PLANNING AMENDMENTS

Client
RFU
Project
**TWICKENHAM STADIUM
EAST STAND EXTENSION**
Drawing title
GA ELEVATION 2

Doc ref	Project number	Drawing number	Revision
100-KSS-DR	15735	301	P03

1 ELEVATION
LEVEL 1 GA - PROPOSED LANDSCAPING
1 : 500

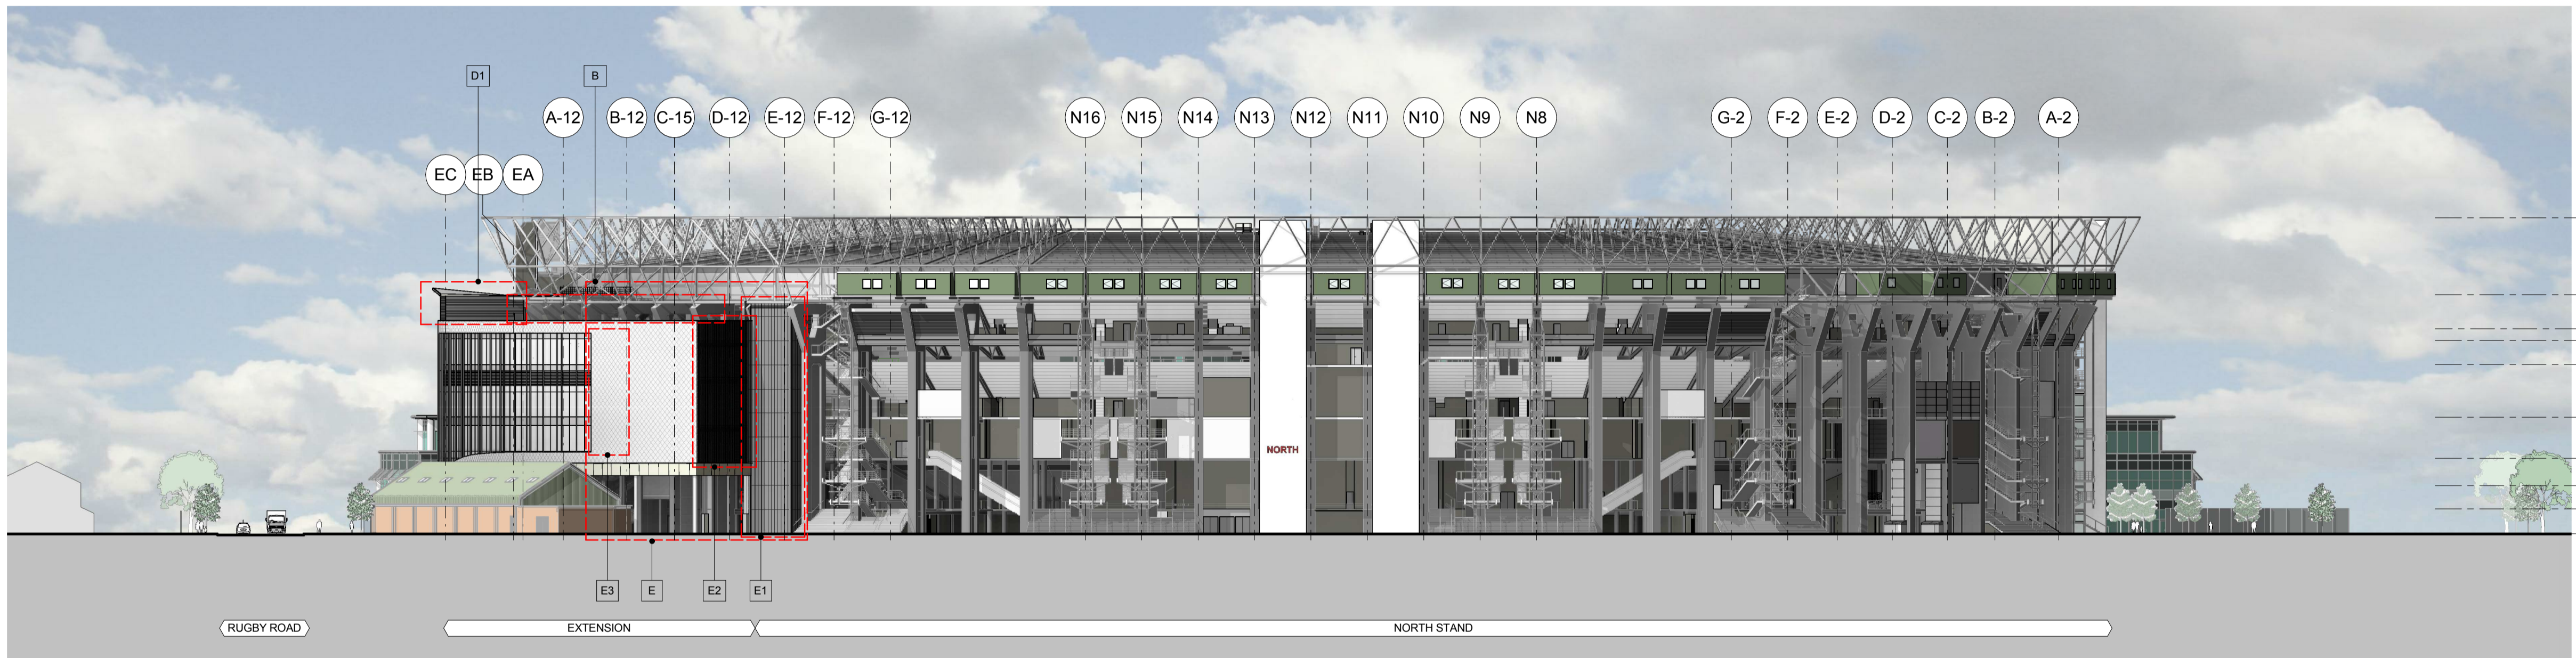
- A GENERAL AMENDMENTS TO THE SOUTH END.
- A1 INCREASED SHINGLES CLADDING AREA AND CURTAIN WALL REDUCED ACCORDINGLY.
- A2 REDUCED MASSING AND REVISED INTERFACE WITH THE SOUTH STAND.

- B PPC LOUVRES LOCATED TO THE BOWL SIDE HAVE BEEN OMITTED.
- C CURTAIN WALL SETTING OUT REVISED GENERALLY. SILICONE JOINTS TO TRANSOMS AND MULLION REPLACED WITH CAPPED SYSTEM. LEVEL 04 PPC LOUVRES: SETTING OUT & HEIGHT REVISED. MONORAIL FOR ABSEILS REMOVED.

- D GENERAL AMENDMENTS TO THE CENTRAL ELEVATION CANOPY AT LEVEL 5A REVISED GENERALLY AND STANDING SEAM REPLACED WITH SINGLE PLY MEMBRANE. SUPPORT COLUMNS TO ROOF CANOPY REVISED. SQUARE FASCIA TO ROOF EDGE.

- D1 LEVEL 5A GLAZED SCREEN EXTENDED IN HEIGHT AND PPC LOUVRES INCLUDED AT LOW LEVEL.
- D2 INCREASED SHINGLES CLADDING AREA AND CURTAIN WALL AREA REDUCED ACCORDINGLY. FOUR VERTICAL FINIS REMOVED.

- D3 PORCELAIN PANELS WITH SLOTTED HOLES FOR VENTILATION REPLACED WITH PPC LOUVRES. EXPRESSED HORIZONTAL PATTERN TO PORCELAIN PANELS OMITTED.
- E GENERAL AMENDMENTS TO THE NORTH END PORCELAIN CLADDING REPLACED WITH PPC ALUMINIUM CLADDING.

- E1 GREEN WALL TO THE NORTH END EXTENDED AND PPC LOUVRES REMOVED.
- E2 INCREASED SHINGLES CLADDING AREA AND CURTAIN WALL REDUCED ACCORDINGLY.
- E3 FENCELINE, GATE AND PERIMETER COLUMNS SETTING OUT REVISED.

- F CANOPY TO TURNSTILES REVISED.
- F1 PORCELAIN PATTERN CHANGED FROM HORIZONTAL TO VERTICAL.
- G PORCELAIN PANELS TO THE SOFFIT OF THE ARCH REPLACED WITH PPC ALUMINIUM PANELS. PORCELAIN PANELS SETTING OUT REVISED.

- H ROOF TO LEVEL 5A (NORTH END) EXTENDED.
- K GLAZED SPANDREL PANELS REPLACED WITH METAL SPANDREL PANEL. PORCELAIN PANELS REPLACED WITH PPC ALUMINIUM CLADDING.

- L1 PPC LOUVRES INCLUDED FOR MECHANICAL VENTILATION.
